HISTORIC AND DESIGN REVIEW COMMISSION

HDRC CASE NO: 2025-090
ADDRESS: 910 E SOUTHCROSS BLVD
LEGAL DESCRIPTION: NCB 7665 LOT SW 200 OF 4 & NE IRR 118.4 OF SW IRR 233. 4 OF C & W IRR 93 OF 15
ZONING: I-1, H
CITY COUNCIL DIST.: 3
DISTRICT: Mission Historic District
APPLICANT: Edward Hernandez/Nirvana Architecture Studio
OWNER: Isarael Ramirez/LIDS CHRISTIAN CENTER INC
TYPE OF WORK: New Construction
APPLICATION RECEIVED: April 09, 2025
60-DAY REVIEW: June 08, 2025
CASE MANAGER: Caitlin Brown-Clancy

REQUEST:

The applicant is requesting conceptual approval to construct a new 10,000 sf building housing an auditorium, classrooms, and various auxiliary spaces on the existing campus of LIDS Christian Center at 910 E Southcross Blvd and site work consisting of a master parking plan.

1 LANDSCAPE PLAN 1"=20'

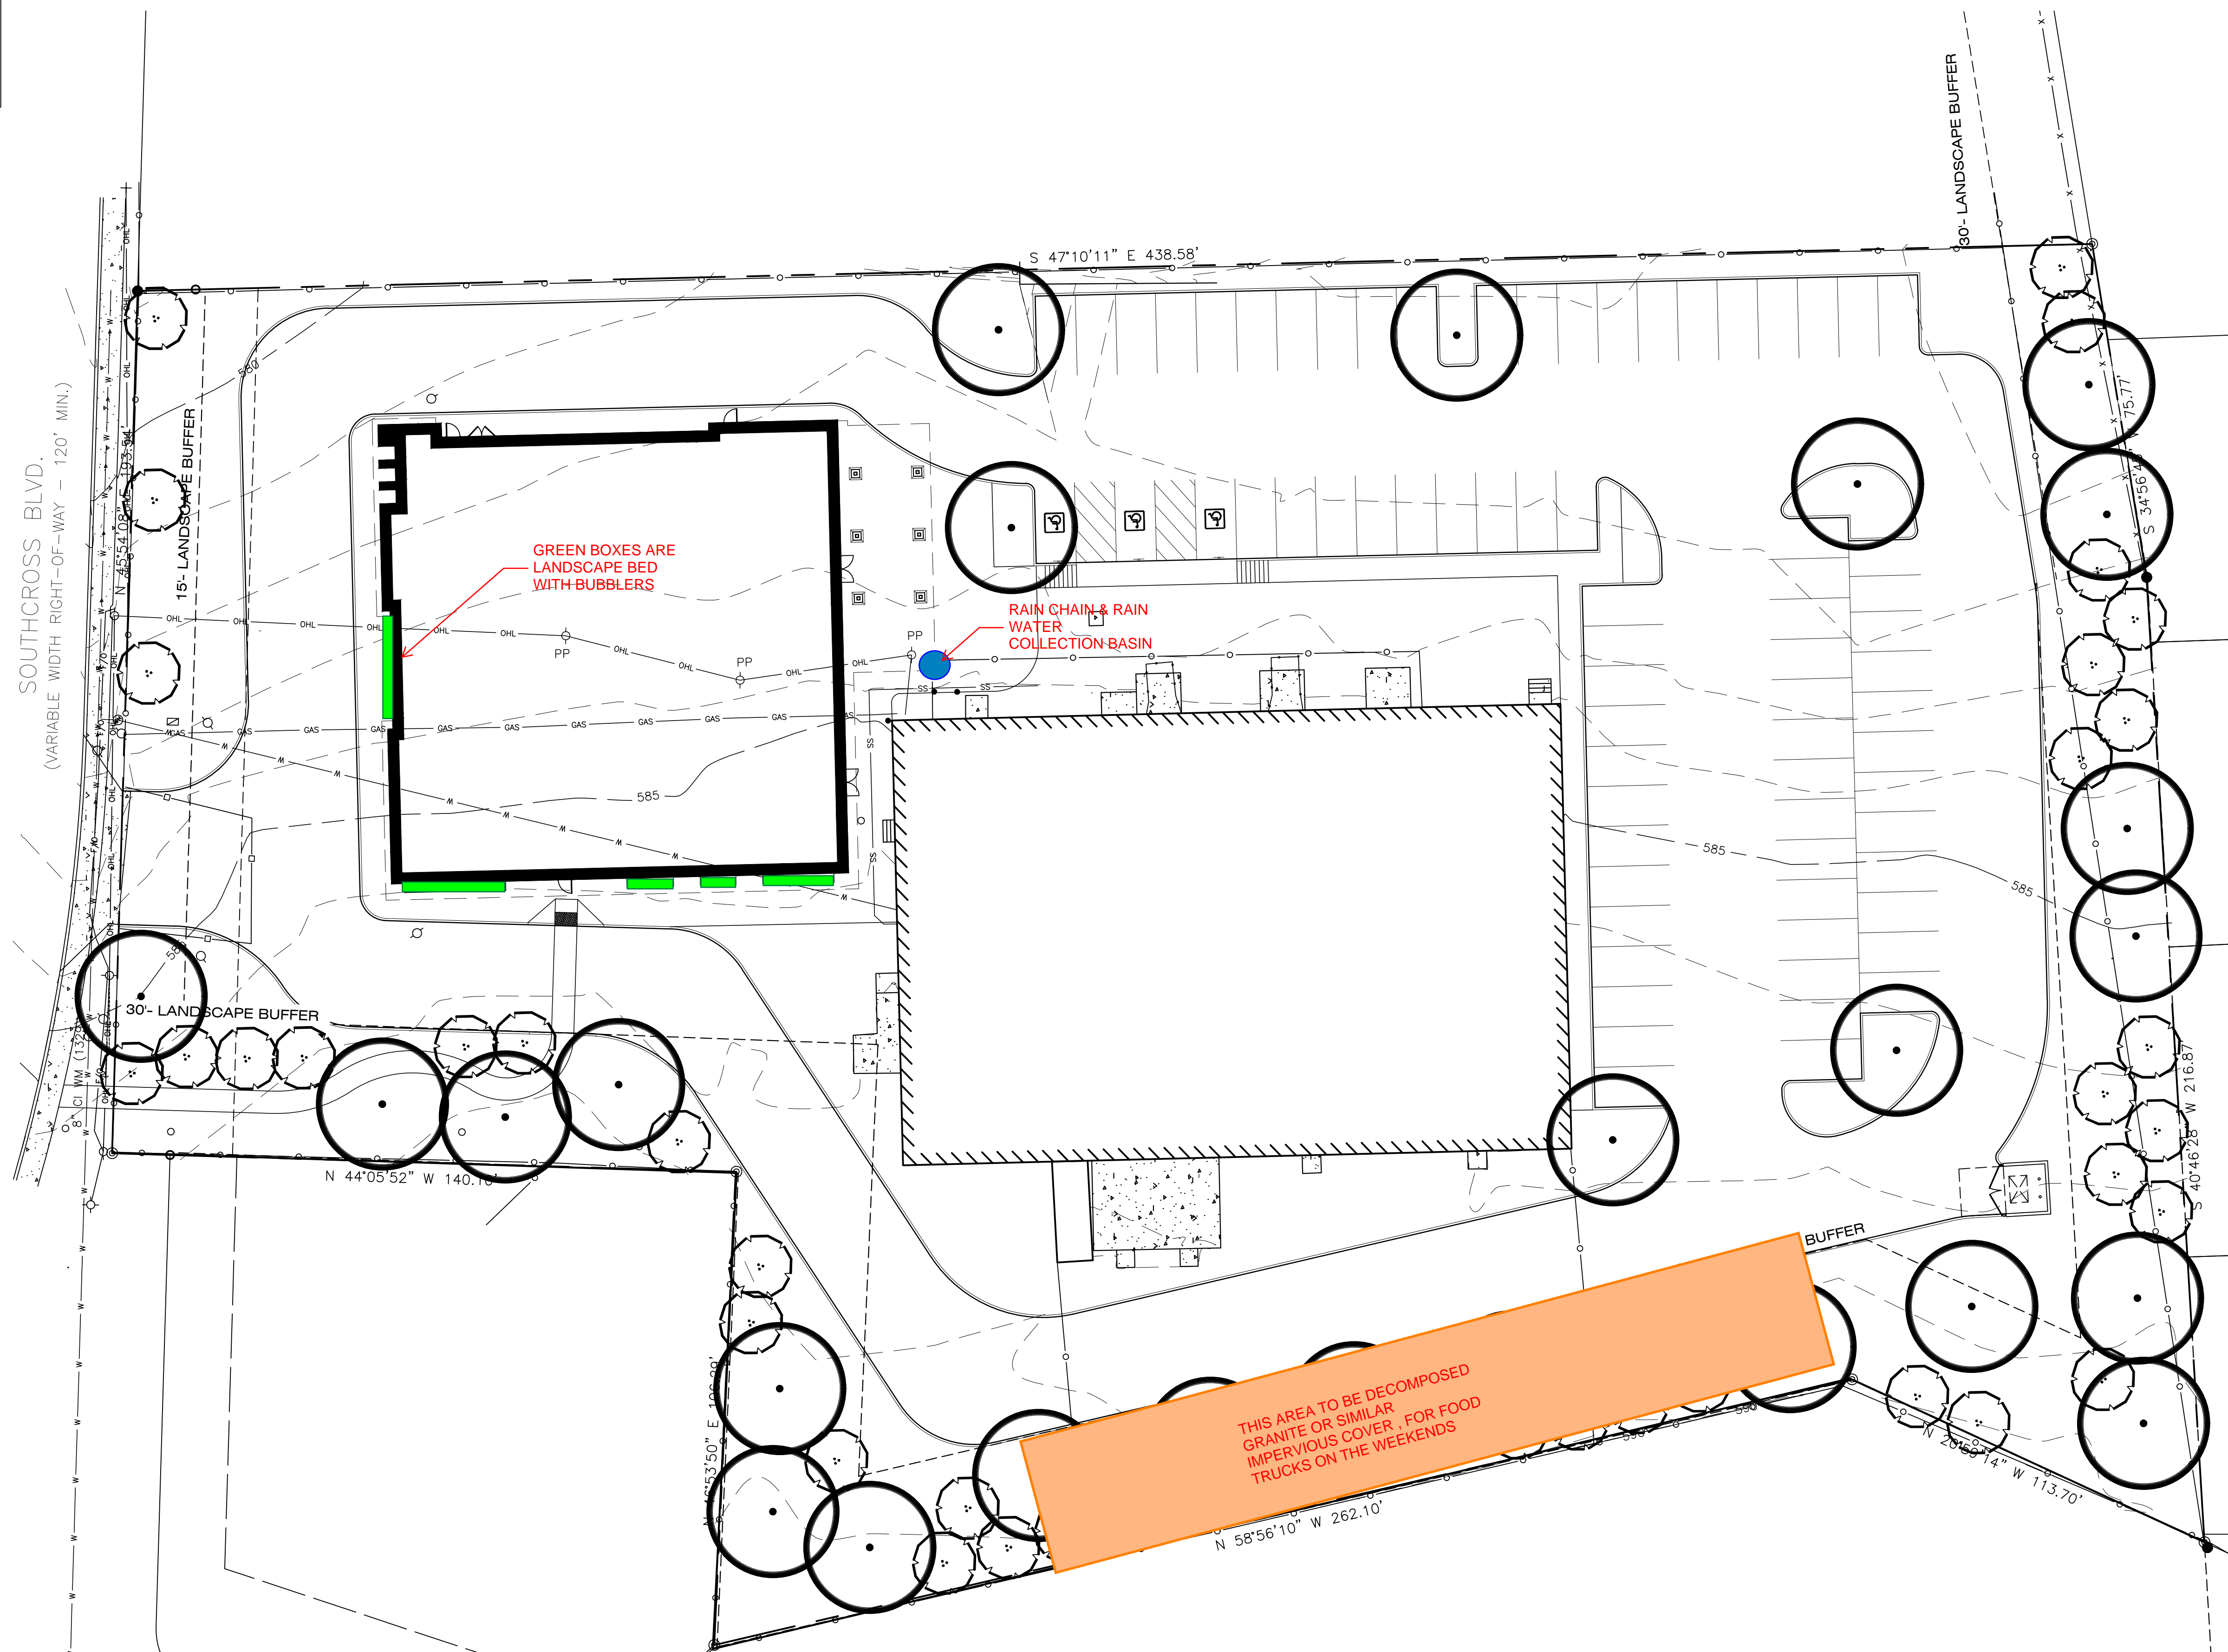
- m. **LANDSCAPE** – The applicant has submitted a conceptual landscaping plan that features a 30'0" wide landscaping buffer on the N, S, and W property lines to include unspecified trees, low plantings, and decomposed granite. Additionally, the site features a few water features at the new construction and unspecified trees throughout the parking lot. Guideline 3.V.iii calls for parking areas to be screened from the sidewalk and street with landscaping to allow a filtered view of the parking area while reducing its overall visual impact. Additionally, Guideline 3.v.i states that canopy trees shall be integrated into the design of surface parking lots to provide shade for a minimum of 25 percent of any individual parking lot. Generally, staff finds the proposed landscaping plan to be appropriate but finds the applicant should submit a final landscaping plan indicating plant and tree species and material specifications that are consistent with the Guideline for review prior to returning to the HDRC for final approval.
